2. Activation and integration with Metro Station

## Podium Facade - Integration of Services

**Figure 1. Detail of vertical fins and decorative screen over louvre banks at podium levels on Elizabeth Street and Castlereagh Street**

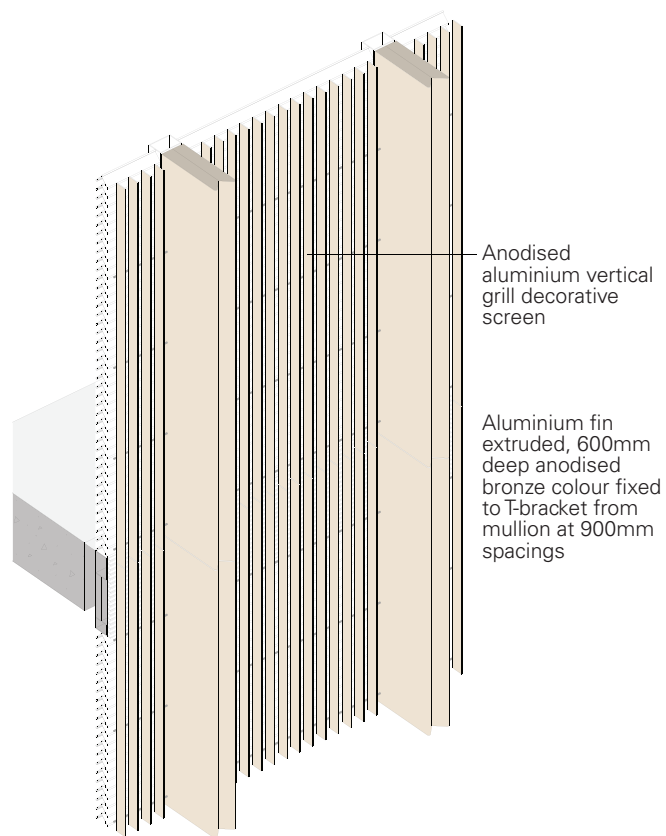
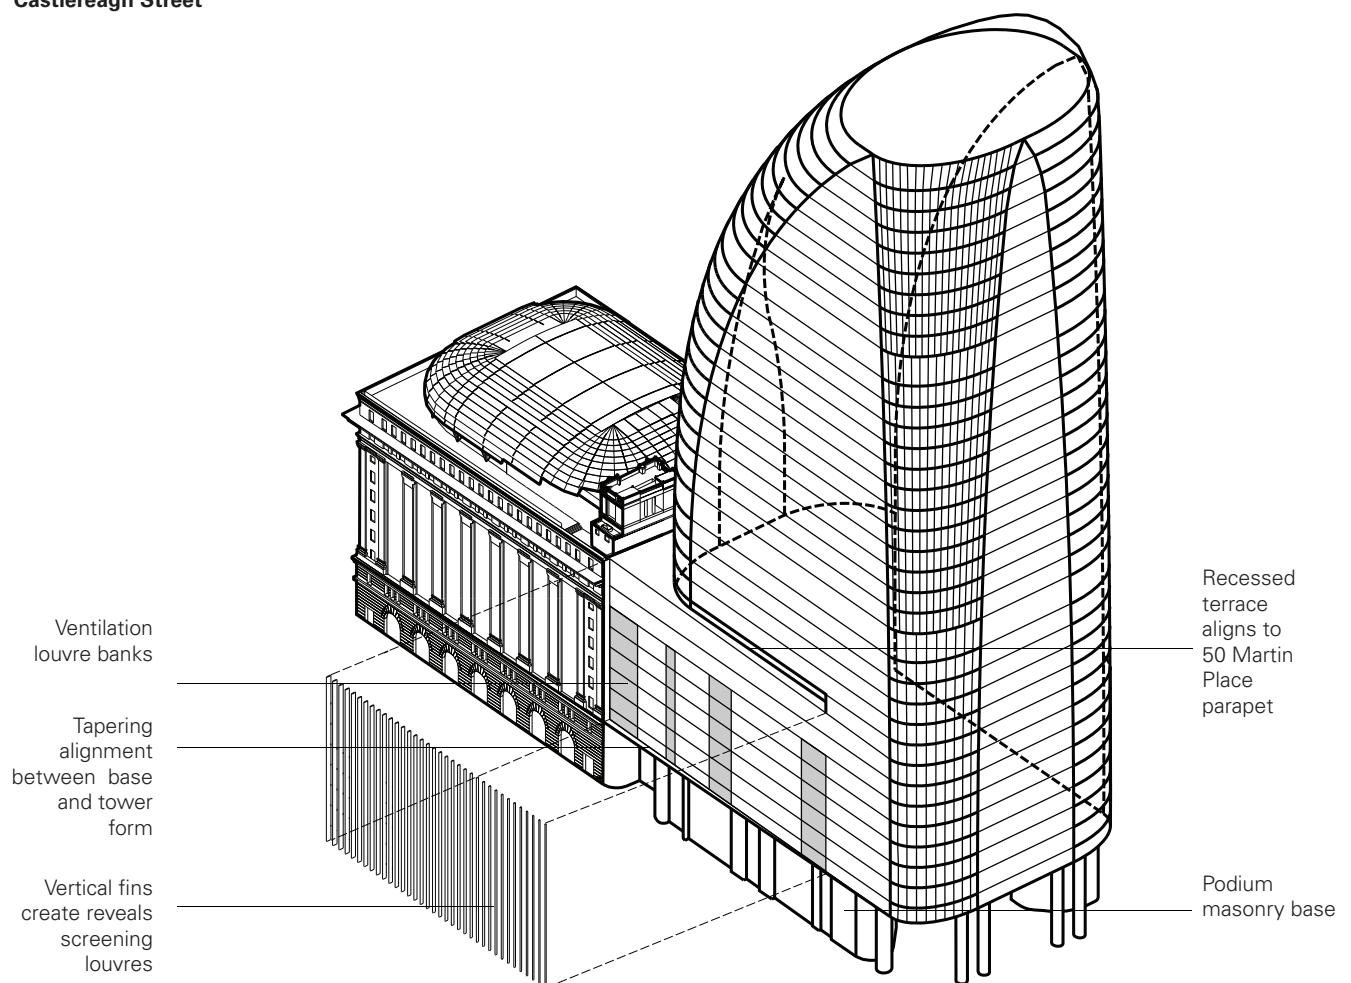
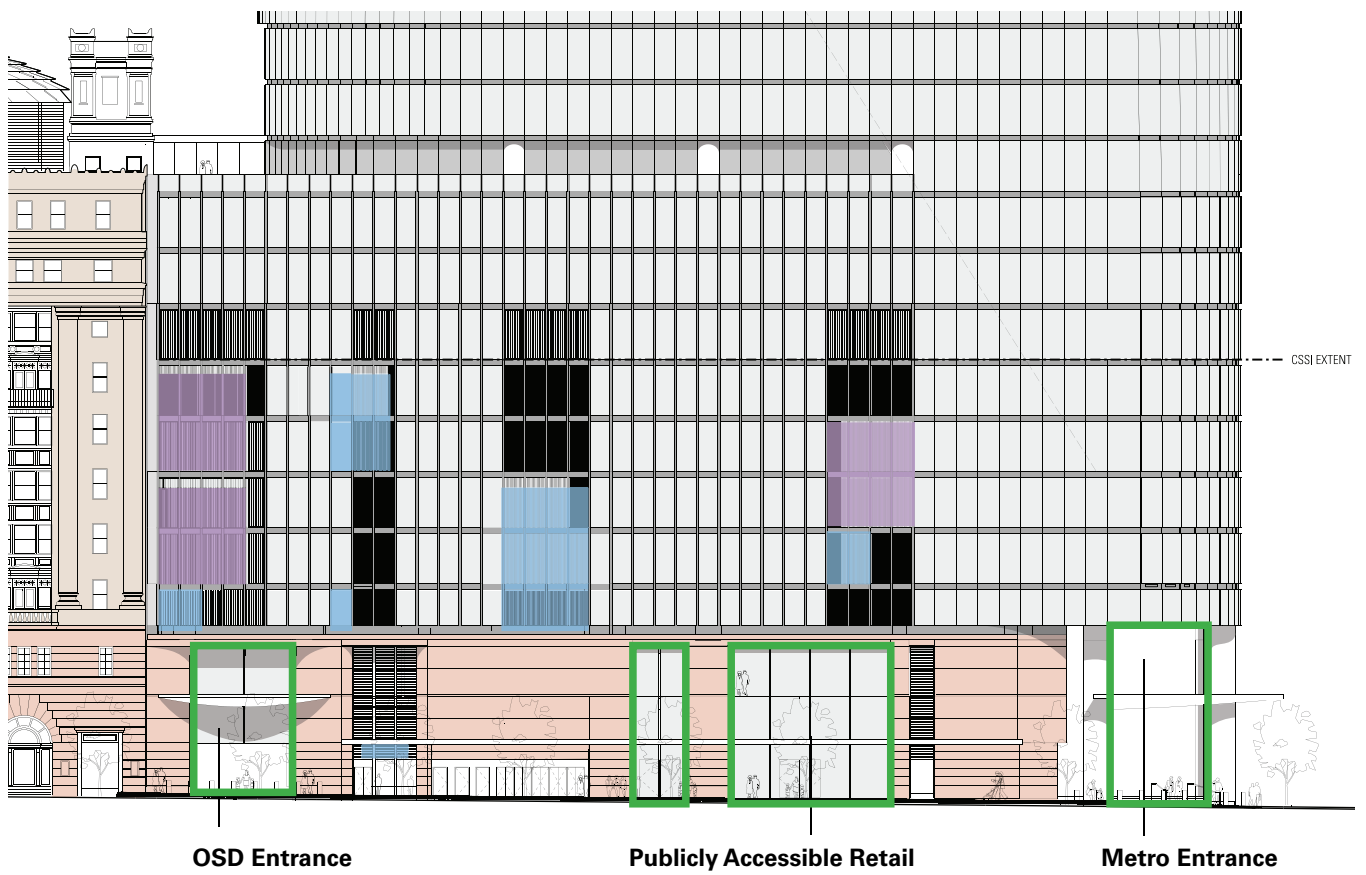
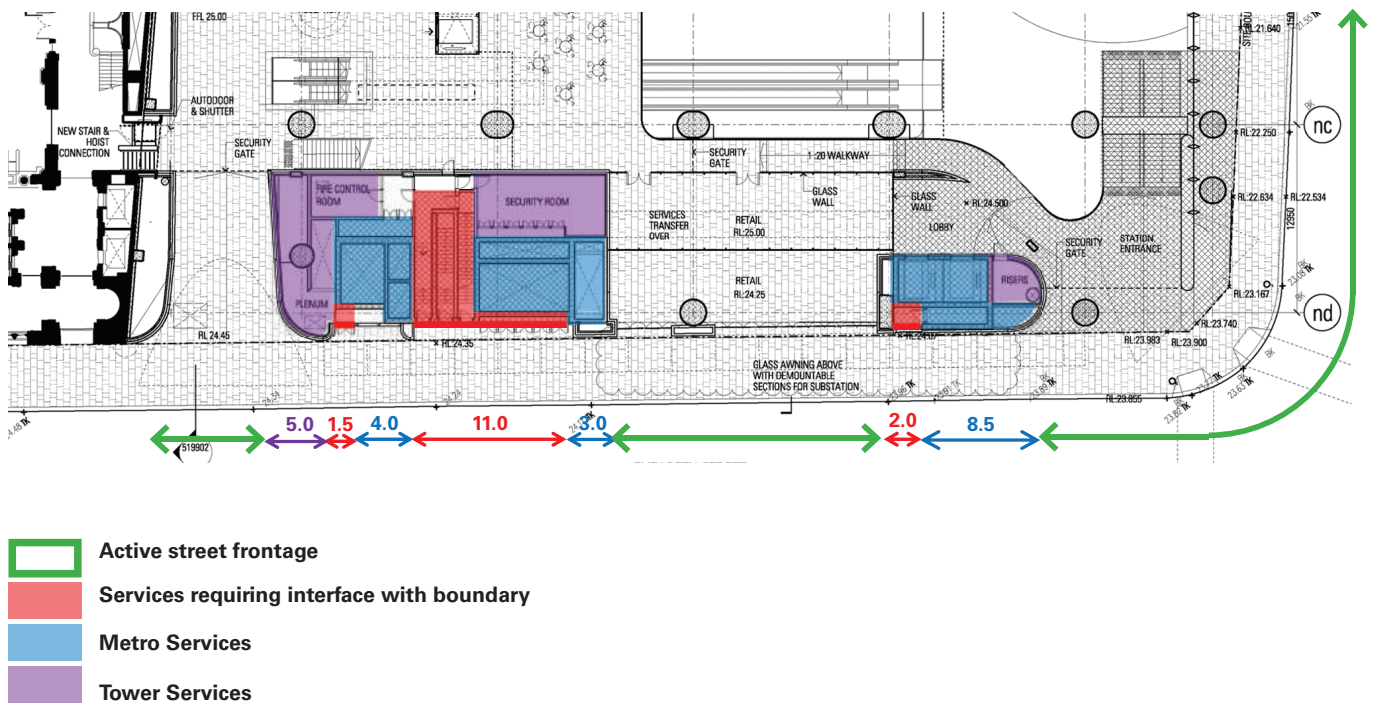
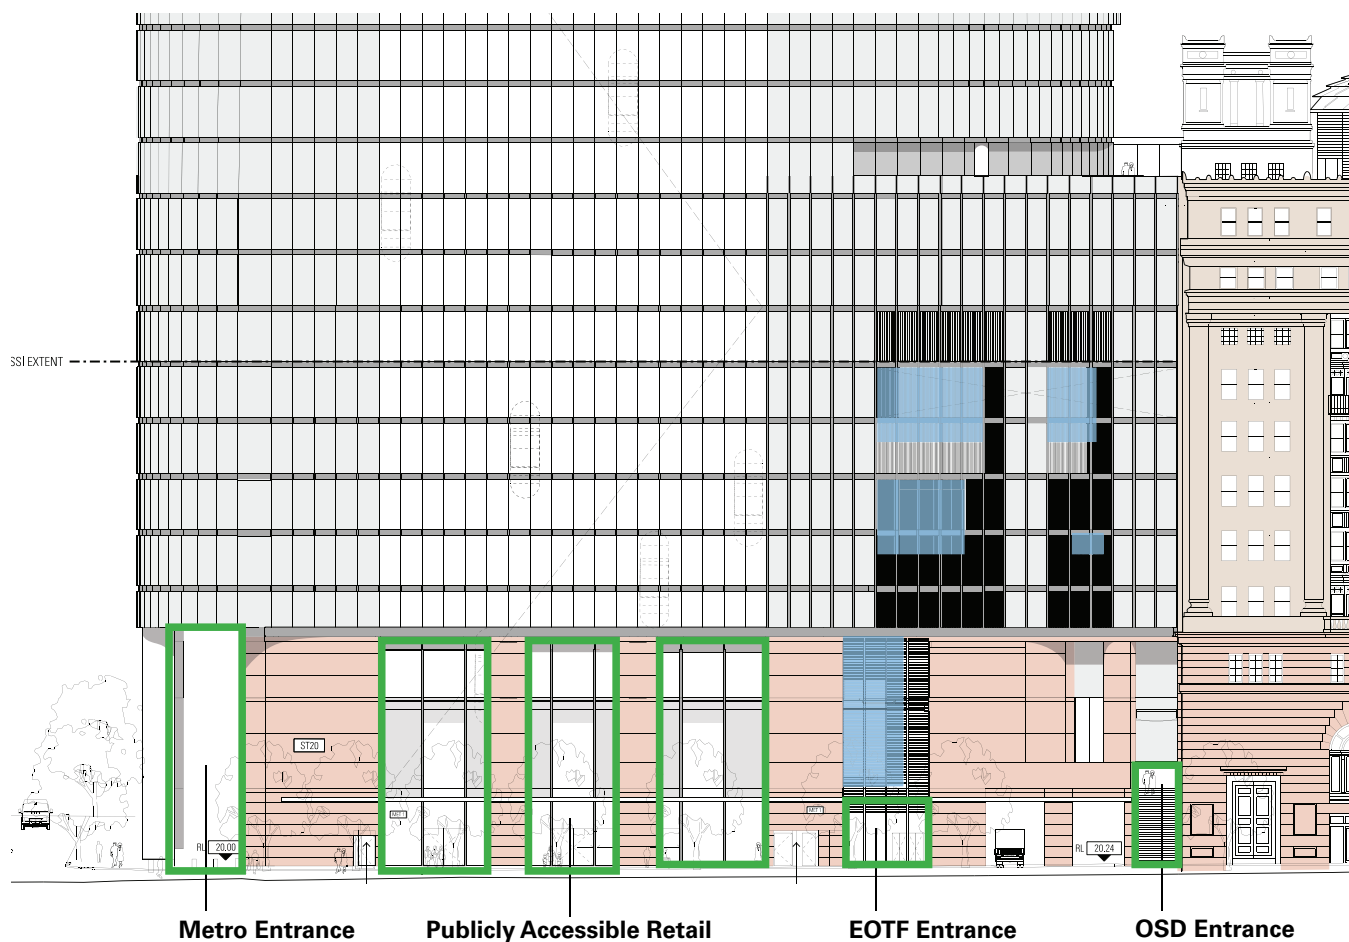
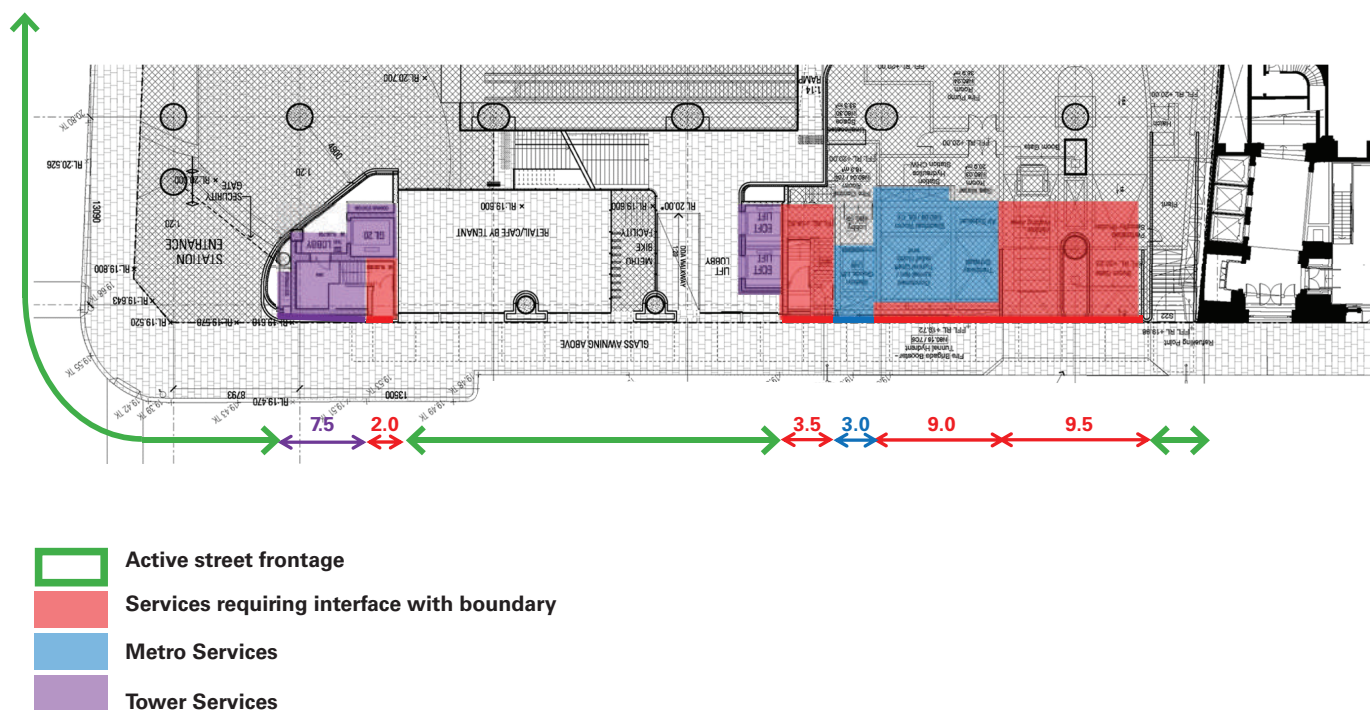
**“IV. Provide details of architectural treatment/integration of services, ventilation and fire egress, etc on street level for both sites.”**

- + Active frontages are maximised by minimising the extent of Tower and Metro station services at ground level of Elizabeth Street and Castlereagh Street.

- + Services and egress requirements are enclosed within street wall granite elements.

- + Vertical fins above are connected to the tower glazing and create deep reveals which screen the extensive Metro services ventilation requirements consolidated in vertical banks in the podium facade.

A composition of monumental sculptural red granite walls form the solid elements at footpath level on Elizabeth St and Castlereagh St. This treatment extends the material and coursing of the red granite base of 50 Martin Place, providing a consistent pedestrian experience. Furthermore, the walls enclose consolidated services and egress requirements and the openings between the granite walls define entries to the tower, retail and the station.

A procession of 8-storey vertical metal fins extend from the granite base to the 50 Martin Place parapet height to manage the transition from 50 Martin Place heritage facade to tower-to-ground along Hunter Street. The fins are connected to the tower glazing and create deep reveals which screen the extensive Metro services ventilation requirements consolidated in vertical banks in the podium facade.

**Figure 1. North Facade signage zone**

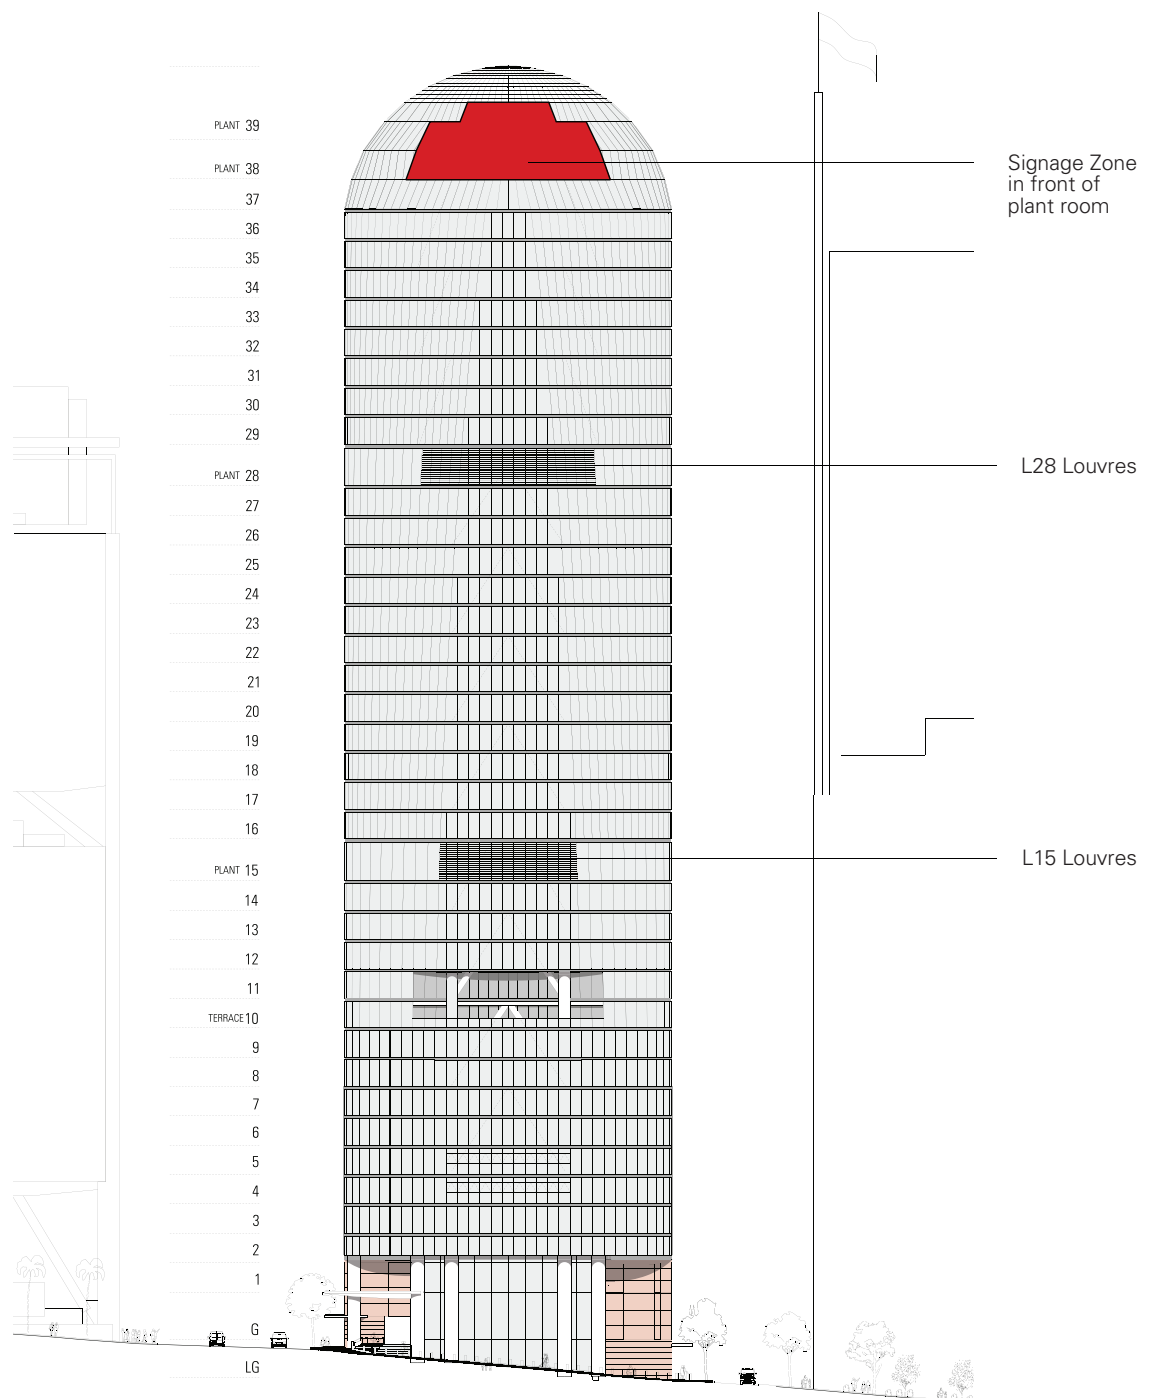
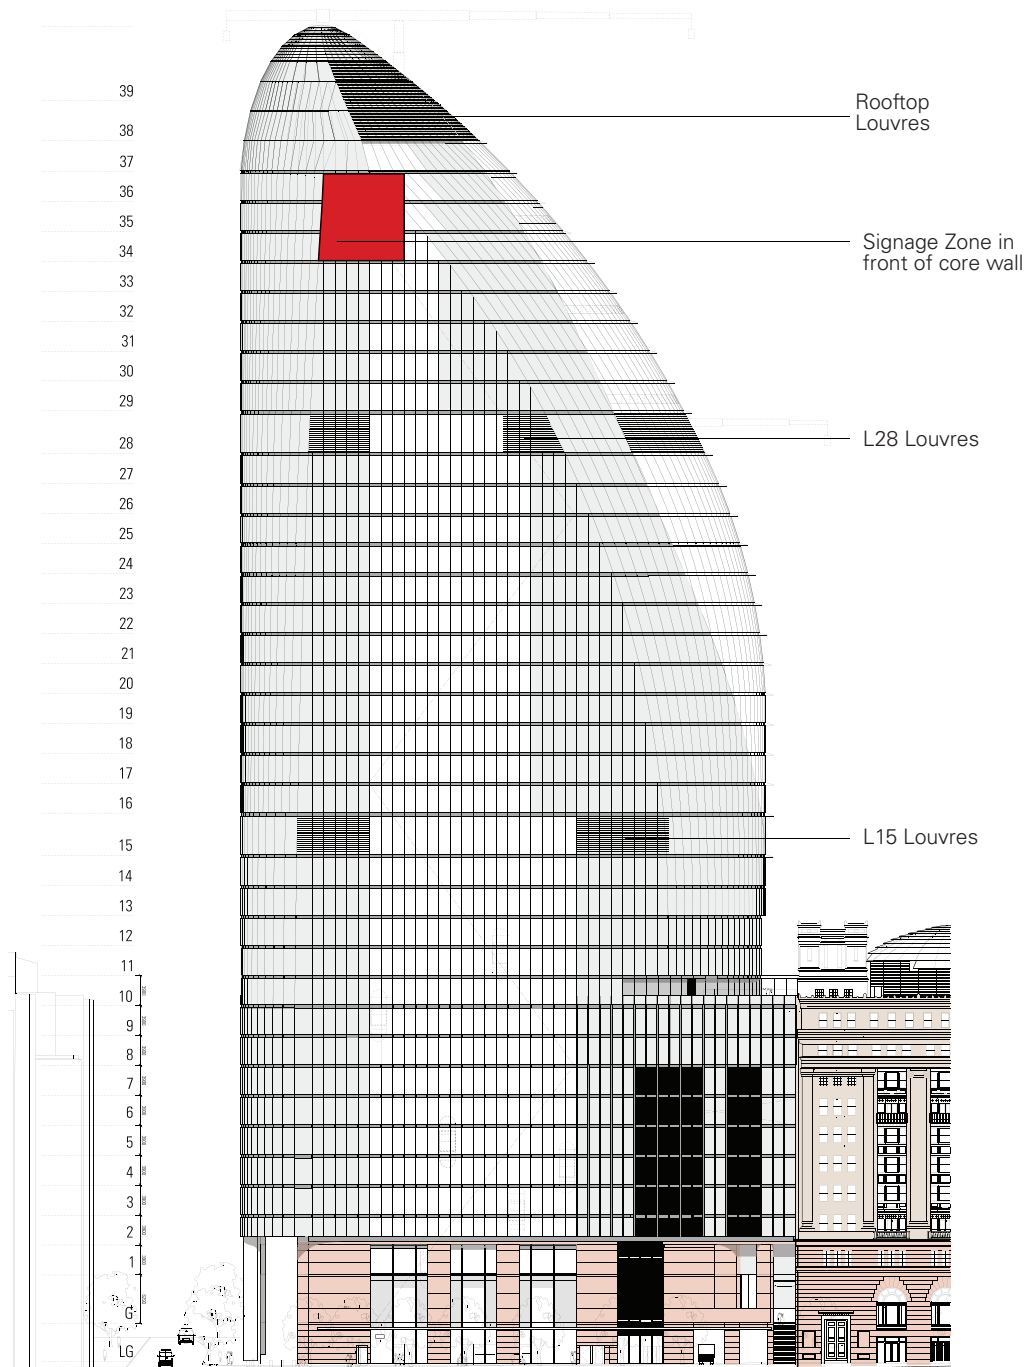
“Consider the appropriateness of the proposed signage zones (and the deferral of detailed design of the signs) with respect to:

I. Integration of proposed signage zones with the curved facade of the North Tower with faceted panels”

Two zones for building signage have been identified at high level where they are prominent and where they will not impact tenant views.

Building signage will be subject to future development applications.
